ORIGINATION FORM

Proposed Revisions to a Standard Plans Index (Please provide all information — Incomplete forms will be returned)

Index Number: 649-020

Index Title: Steel CCTV Pole

DETAIL "E"

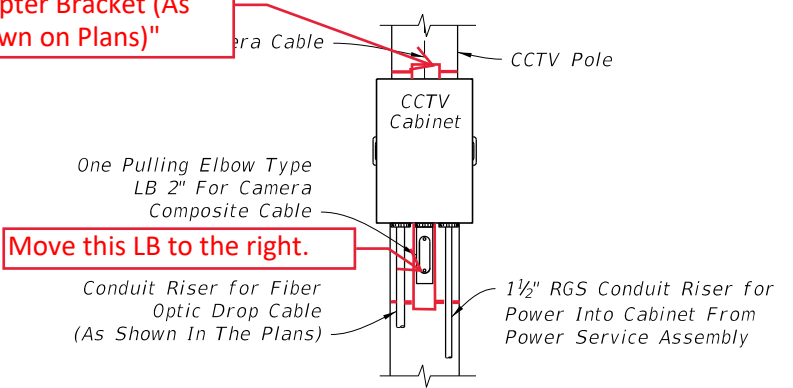
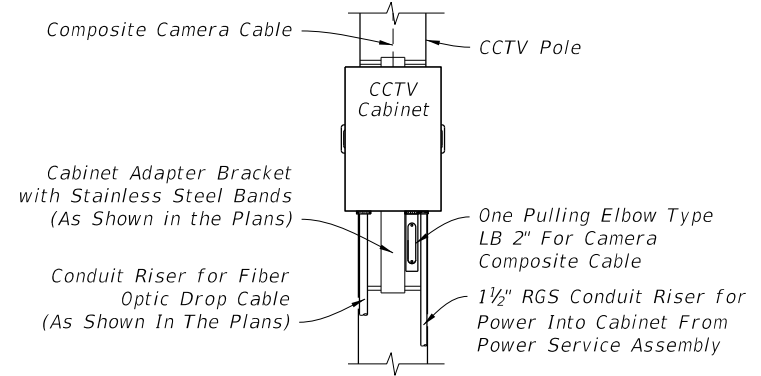
Sheet 6: Deleted the "Pole Plate With Stainless Steel Band" and Added new "Cabinet Adapter Bracket" shown in DETAIL "E" and the POLE MOUNTED CABINET detail.

Add note: "Cabinet Adapter Bracket (As Shown on Plans)"

Move this LB to the right.

"676-2.5.9 Adapter Bracket: If shown in the plans, provide an adapter bracket for pole mounted cabinets that is slotted or otherwise designed to allow banding straps to be installed to avoid pole handholes."

POLE MOUNTED CABINET

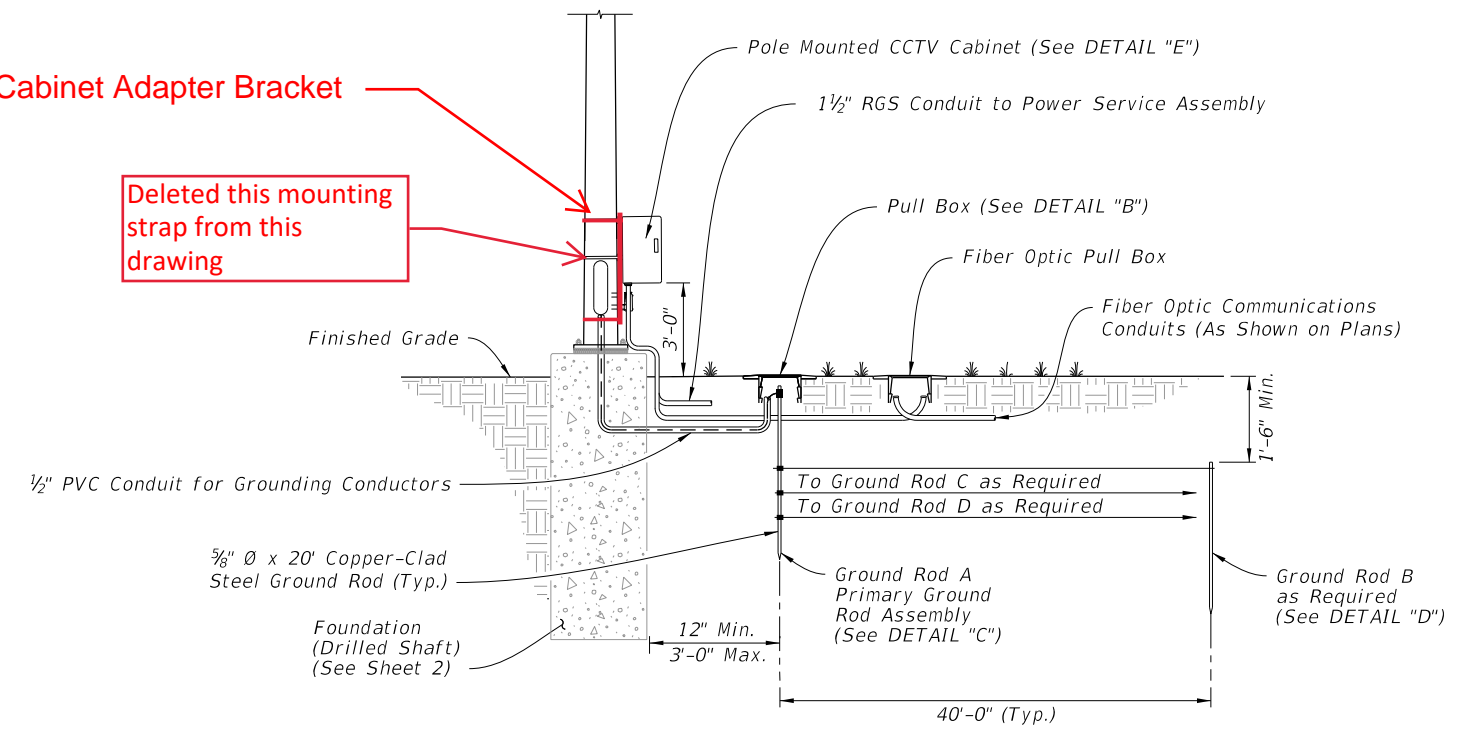
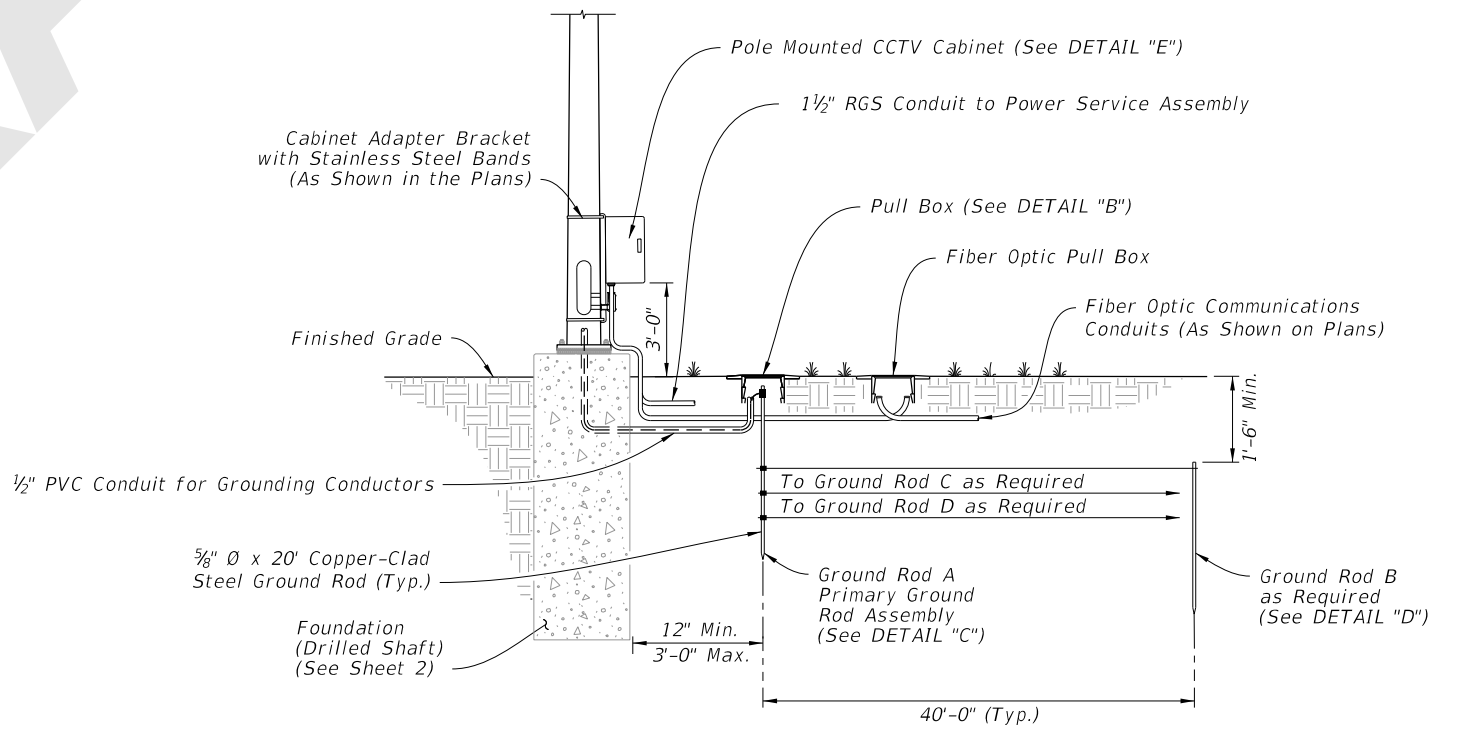
The CCTV pole hand hole had been vertically elongated, however, the CCTV cabinet bracket locations remained the same. As a result, when mounted, the CCTV cabinet mounting straps partially cover the CCTV pole hand holes.

Added: Cabinet Adapter Bracket

Deleted this mounting strap from this drawing
